Pre-Grid Punch List CFA 5702

Prepared by Will Turnbough

Jul 10, 2025

Screenshot 2025-07-10 132714

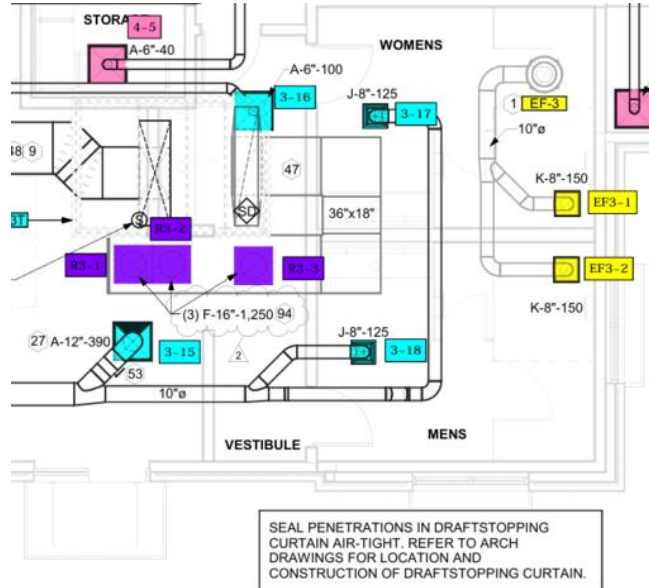
Diffuser 3-18 has additional bend in duct that needs to be removed.

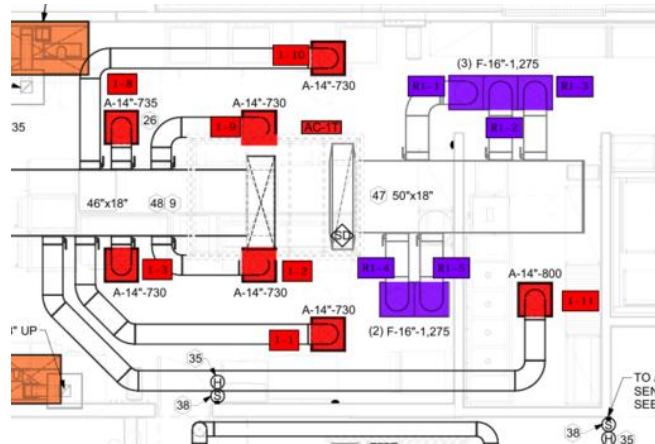
Ductwork for diffusers 1-1 and 1-11 are not installed per design. They have a 90 degree instead of 45 degree transitions which could impede airflow.

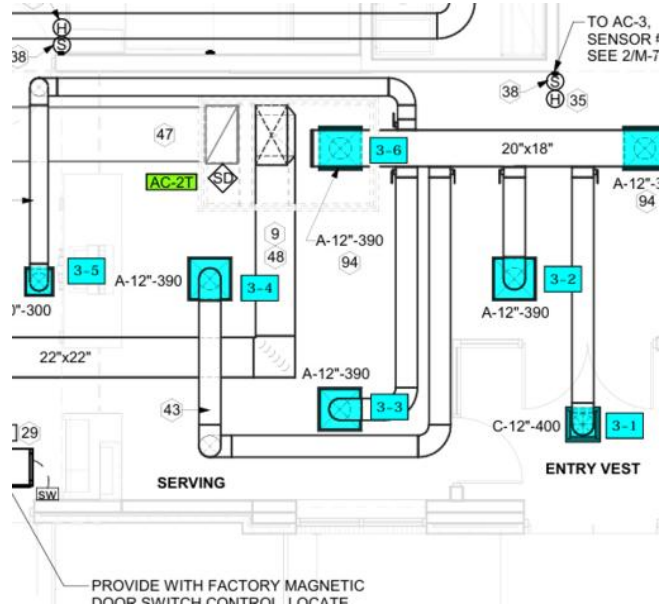
Diffuser 3-3 has additional transitions added in the duct run that will likely cause issues getting airflow to design. Appears that 3-4 duct run was installed in wrong spot which caused the deviation. This should be corrected.

IMG_3021

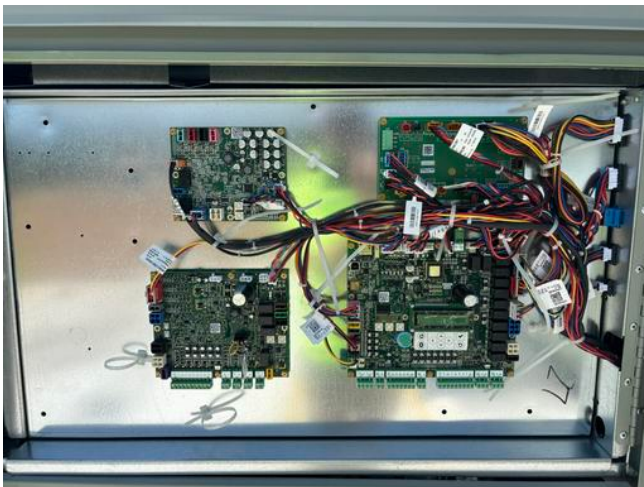
Temperature and humidity sensor wiring is not installed yet. Temperature sensor wiring should be CAT 5/5E and the humidity sensor wiring should be 18/2 shielded, twisted, pair typical of Belden 8760

IMG_3021

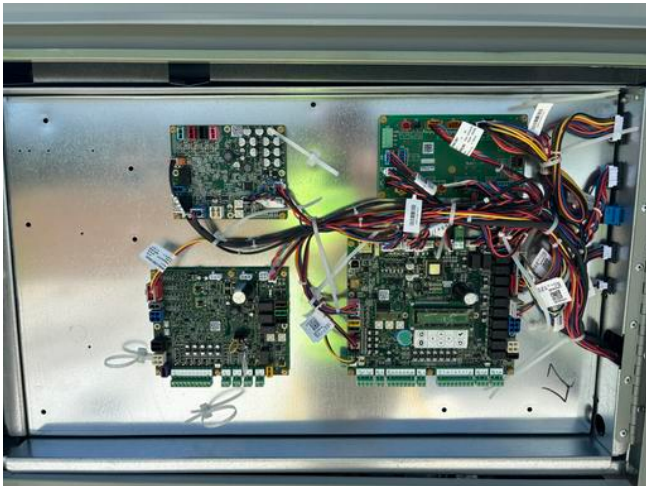
FAT Tempering kits have not arrived from Trane yet per the MC. Install probe in the supply duct after the first 90 degree transition.
